MEMORANDUM

To: Susan Gordon, Multicultural Alliance for a Safe Environment (MASE) and Candace Head-Dylla, Bluewater Valley Downstream Alliance (BVDA)
From: Ann Maest, PhD, Buka Environmental
Date: 24 November 2019
Re: Evaluation of background selenium concentrations in the alluvial, mixed Chinle, Upper Chinle non-mixed, Middle Chinle non-mixed, and Lower Chinle non-mixed aquifers at the Grants Reclamation Project, New Mexico

Figure 4. Dissolved selenium concentrations in near upgradient, selected background alluvial wells. The red dashed line indicates the GWPS of 0.32 mg/L Se, and the vertical black lines indicate the selected time period of 1995 to 2004.

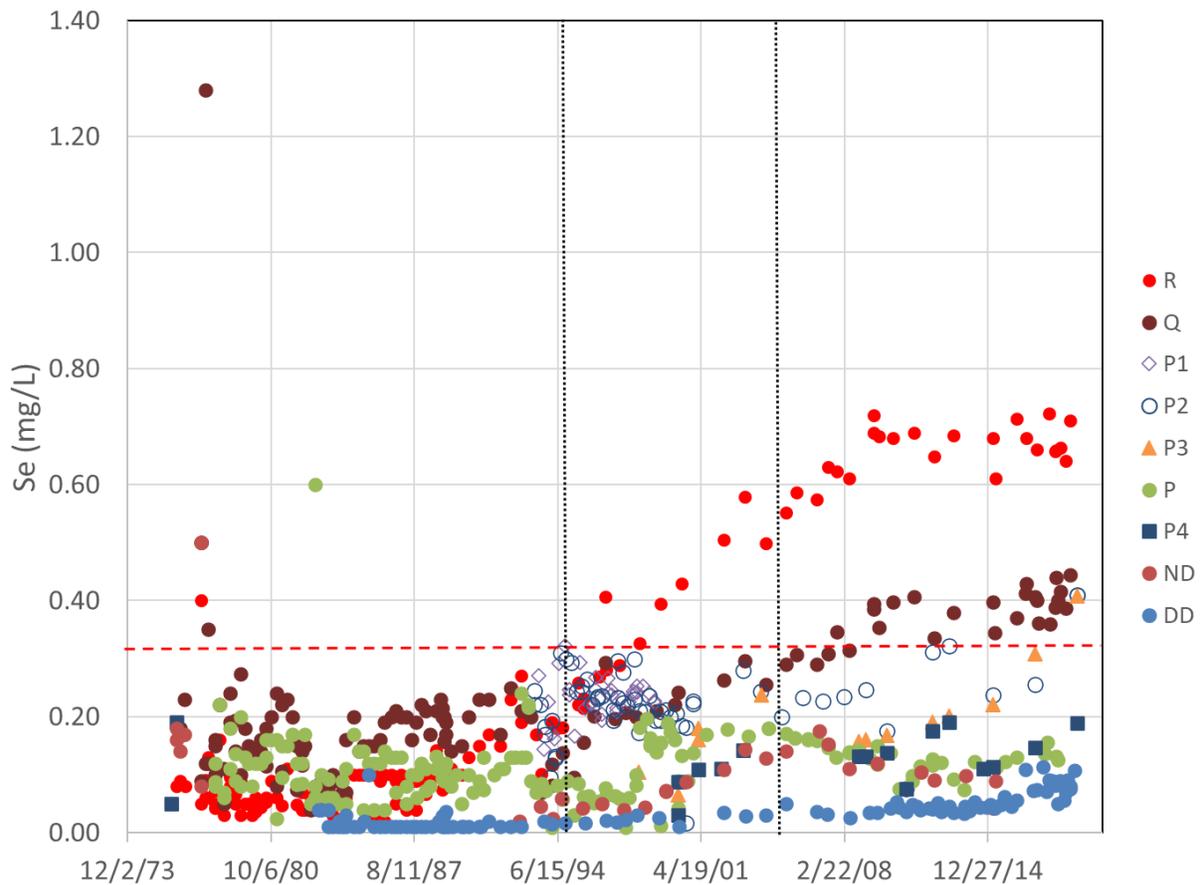
However, very few wells in the center of the alluvial aquifer are unaffected by mine-influenced water in the period 1995 to 2004, as shown in Figure 5. All alluvial wells except DD, P1, and P2 used in the current GWPS evaluation had increasing concentrations of selenium during this time period, indicating mine-related influence, likely from upgradient mines in the San Mateo Creek basin. Because the selenium plume appears to be moving more rapidly from upgradient mining sources than the uranium plume, earlier sampling results are less likely to be impacted.

As noted in Homestake (2015, p. 1-3), selenium and nitrate concentrations in wells Q and R showed impacts from upgradient mining beginning in the mid-1990s. Therefore, these two wells should not be used for background determination, especially in the period 1995-2004.

The proposed GWPS exclude wells Q and R and use wells P (1995-1997), DD (1981-2014), ND (1983-1998), and 916 (1994-2005). Selenium concentrations in wells P1 and P2 have consistent concentrations over the narrow period of sampling (see Figure 5), but concentrations are similar to those in R and Q, which are known to be affected by mining-related sources. While wells R and Q had lower concentrations before the early 1990s, wells P1 and P2 were not sampled during this timeframe. P3 concentrations increased from the first sampling, so this well was excluded from consideration as background. Well P concentrations jumped in 1998, and concentrations from 1998 forward are not used.

Figure 8. Dissolved selenium concentrations in all Chinle Mixing Zone wells used for background. The red dashed line indicates the GWPS of 0.32 mg/L Se.

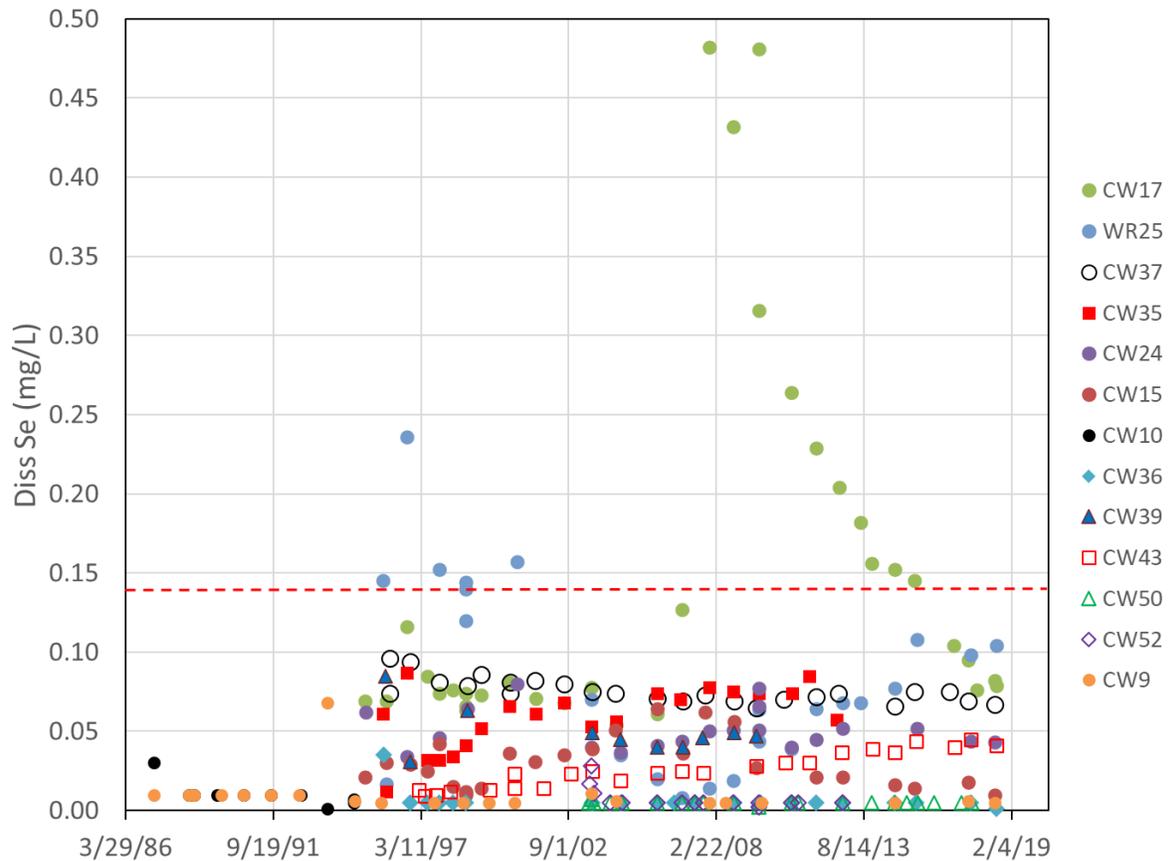
The selenium concentrations for all wells used in the background evaluation are shown in Figure 8. Wells CW17 and WR25 are clearly influenced by mining activity – WR25 in the mid/late 1990s and CW17 starting in 2006. Without these mining-influenced points, Chinle Mixing Zone Se background would be substantially lower than the current GWPS of 0.32 mg/L. The Chinle Mixing Zone was divided into its three aquifer components – Upper, Middle, and Lower – and each Chinle Mixing Zone is discussed in the following sections.

Figure 8a. Dissolved selenium concentrations in the Upper Chinle Mixing Zone wells used for background (1987 – 2017). The red dashed line indicates the GWPS for the Chinle Mixing Zone of 0.14 mg/L Se, and the purple dashed line indicates the GWPS for the Upper Chinle Non-Mixing Zone of 0.06 mg/L.

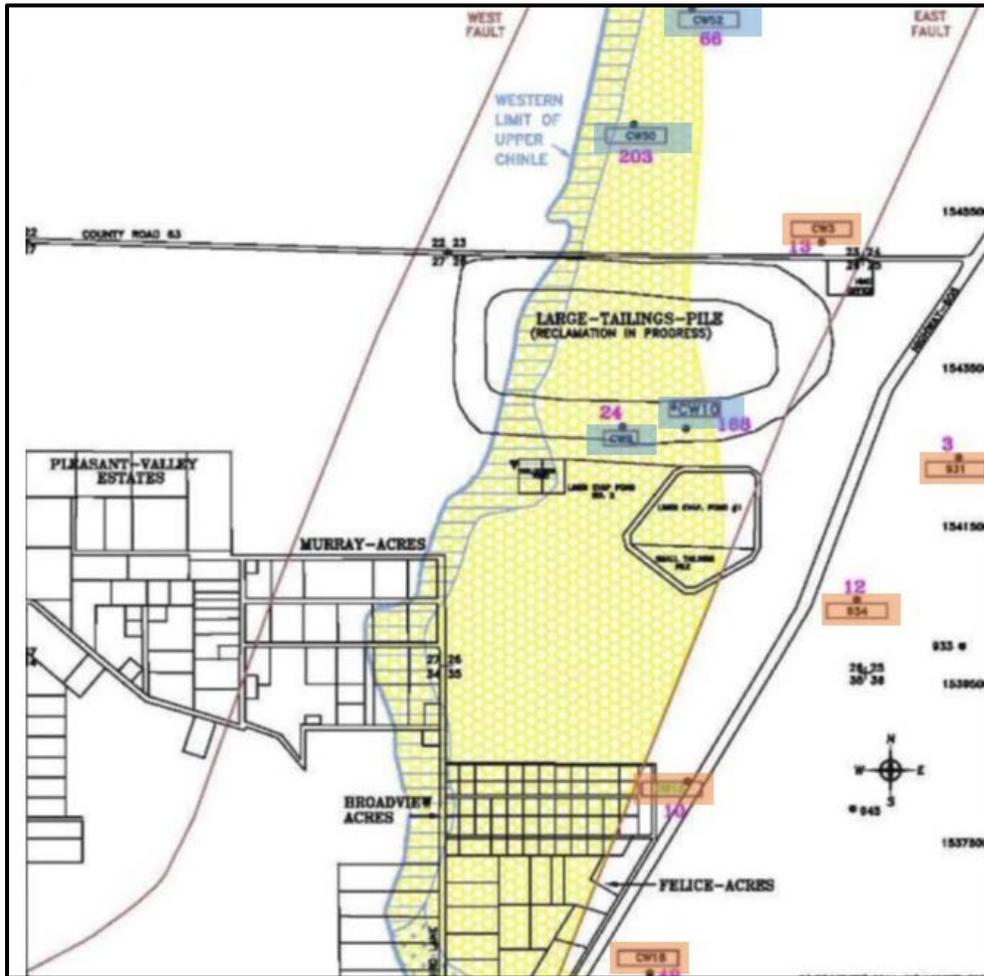
The selenium concentrations in the Upper Chinle Mixing Zone are shown in Figure 8a for all results in the Homestake database. The circled point for well CW9 shown in Figure 8a was eliminated as an extreme outlier because it was more than six times higher than the other CW9 values, and 11 of the 22 CW9 values were below detection at 0.006 or 0.005 mg/L.

The location of the Upper Chinle aquifer is shown in Figure 8a.1, with the subcrop below areas of saturated alluvium depicted in blue horizontal lines. Wells CW9 and CW10 are located at depth under the LTP, and wells CW50 and CW52 are located at depth north of the LTP. The wells do not appear to be affected by milling activity. The 95th percentile was calculated using all data shown in Figure 8a except the high circled point for CW9. The 95th percentile for the Upper Chinle Mixing Zone data is 0.011 mg/L using 68 data points with 67.7% below detection at 0.005 or 0.006 mg/L.

Figure 8b. Dissolved selenium concentrations in the Middle Chinle Mixing Zone wells used for background (1995 – 2018). The red dashed line indicates the GWPS for the Chinle Mixing Zone of 0.14 mg/L Se, and the purple dashed line indicates the GWPS for the Middle Chinle Non-Mixing Zone of 0.07 mg/L.

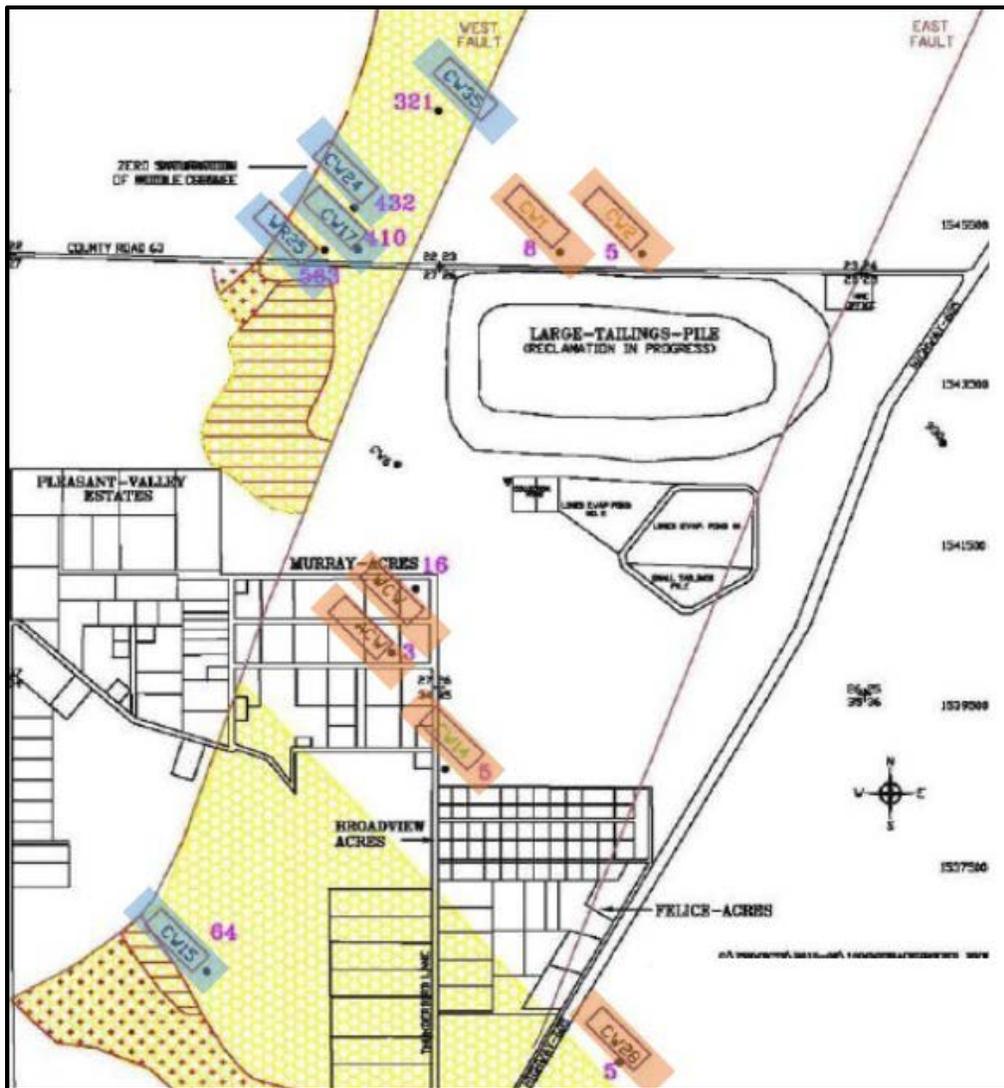
Selenium concentrations in the Middle Chinle Mixing Zone from 1995 to 2018 are shown in Figure 8b. The locations of all Middle Chinle wells (mixing zone and non-mixing zone) are shown in Figure 8b.1. Results from well CW17 (see Figure 8b) were eliminated from consideration because early values contained notable unexplained spikes; values increased sharply in November 2006 followed by a steady decrease in concentrations, indicating mining influence. All values for well WR25 were eliminated from consideration. Early results for well WR25 contained spikes from October 1995 to October 2000, and values from November 2007 to July 2015 consistently increasing, indicating mining influence. Using all the remaining 68 values in Figure 8b, the 95th percentile is 0.078 mg/L Se; no values were below detection.

Figure 9a. Dissolved selenium concentrations in the Upper Chinle Non-Mixing Zone wells used for background. The red dashed line indicates the current GWPS for the Upper Chinle Non-Mixing Zone of 0.06 mg/L Se.

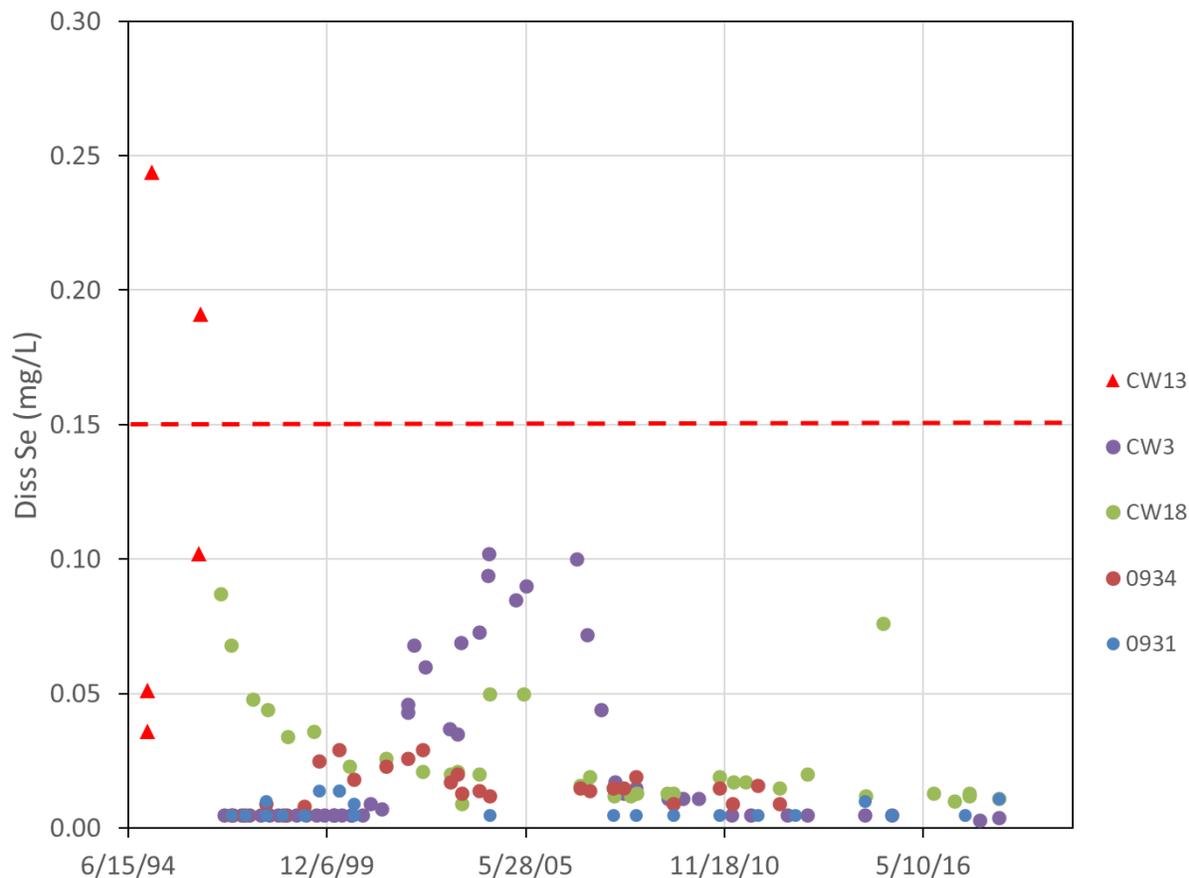
Selenium concentrations for the NRC-selected Upper Chinle Non-Mixing Zone wells are shown in Figure 9a. Well CW13 concentrations are high and erratic - it is used as a remediation freshwater injection well, and none of the results should be used for background. Results from February 2002 onward in well CW3 should be excluded because they reflect increasing concentrations from mining-influenced sources (concentrations increased more than eight times; all previous concentrations were below detection). All Well CW18 data should be excluded completely because concentrations were high initially (first sample was collected in January 1997) and more recent concentrations may not yet reflect lower pre-mining background levels.

Of the 48 remaining selenium results, 70.8% were below detection at 0.005 mg/L, and the 95th percentile value is 0.024 mg/L Se.

Figure 9. Dissolved selenium concentrations in the Middle Chinle Non-Mixing Zone wells used for background. The red dashed line indicates the current GWPS for the Middle Chinle Non-Mixing Zone of 0.07 mg/L Se.

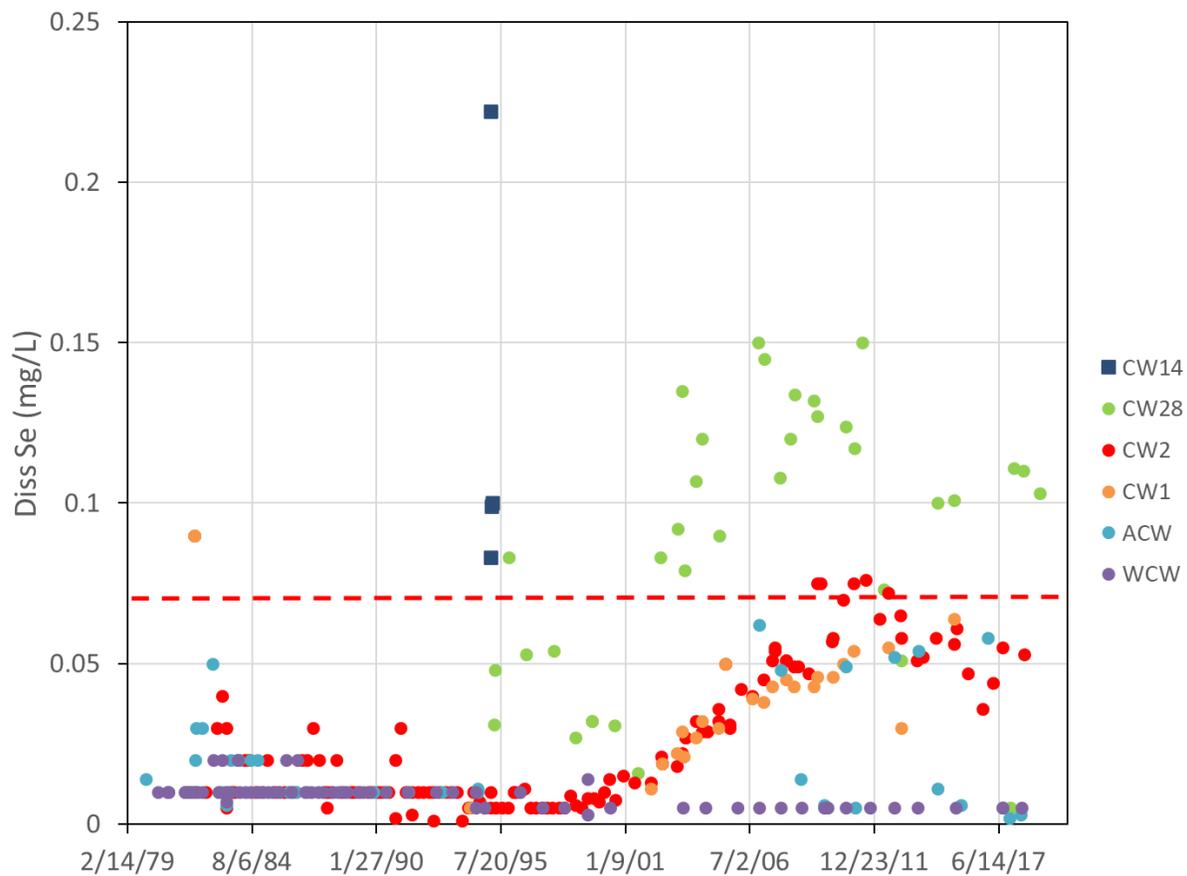
Selenium concentrations in the Middle Chinle Non-Mixing Zone are shown in Figure 9. Concentrations in well CW14 are substantially higher than any of the others. The fact that CW14 is a water injection well for remediation implies that this area had elevated concentrations of COCs and needed to be remediated. Values for CW14 are excluded from consideration in assessing background water quality for selenium. Selenium concentrations in well CW28 began to rise after the first sampling in the mid-1990s and must be excluded as not representative of background. CW1 and CW2 are pumped for remediation (collection wells), also indicating that this area just north of the LTP was affected by mine-influenced water. Concentrations in CW1 and CW2 began to rise in the late 1990s and may not have returned to possible background values. Therefore, concentrations since 2000 should not be used for background. Early spikes are also unexplained and were excluded. Concentrations in well WCW were at or slightly above the detection limit of 0.01 mg/L, which decreased to lower detection limits of 0.005 or 0.003 mg/L in the mid-1990s. Concentrations in ACW spiked in the early years and have been more consistently elevated since 2000. Early spikes in Se concentrations in wells CW1, CW2, and ACW (see Figure 9) have not been explained but possibly reflect intermittent releases from the LTP. Excluding the spikes and samples with increasing concentrations leaves a sample size of 108 data points, with 79% below detection. The 95th percentile of the data is 0.027 mg/L Se.

Figure 10. Dissolved selenium concentrations in the Lower Chinle Non-Mixing Zone wells used for background. The red dashed line indicates the GWPS for the Lower Chinle Non-Mixing Zone of 0.32 mg/L Se.

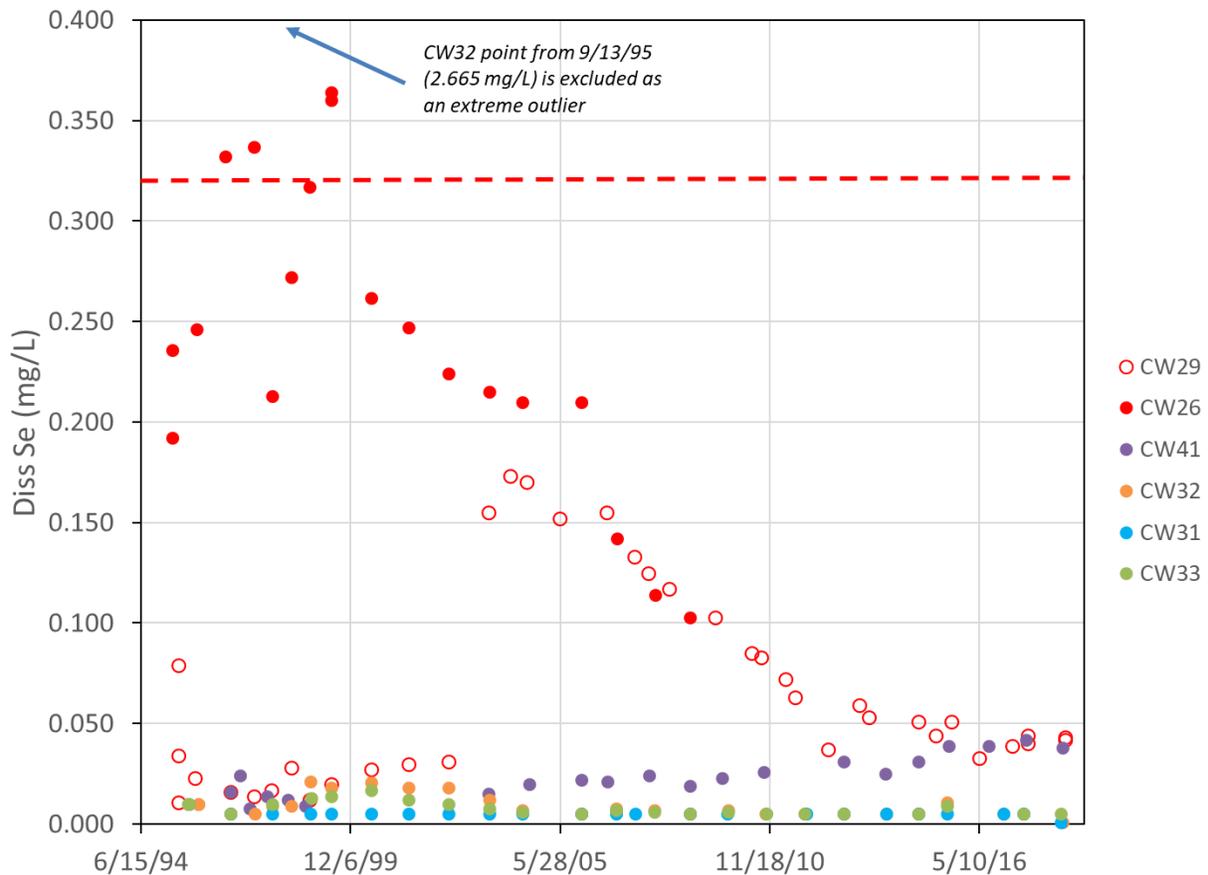
Concentrations in wells CW26 and CW29 should be excluded from background because concentrations in CW26 were high initially and have decreased, but they have not decreased to values similar to other wells (CW32, CW31, CW33), indicating mining influence. Se concentrations in well CW29 increased markedly in July 2003 and remain elevated relative to most of the other values shown in Figure 10. It is unclear if even whether the earlier values from the mid to late 1990s were also affected by mining. The extreme outlier for CW32 (2.665 mg/L) is excluded from consideration for background. Se concentrations in well CW41 began to rise by at least 2010, indicating mining influence, and will be excluded from 2010 onward. Using the remaining 87 data points, 52.9% are below detection, and the 95th percentile is 0.022 mg/L selenium.
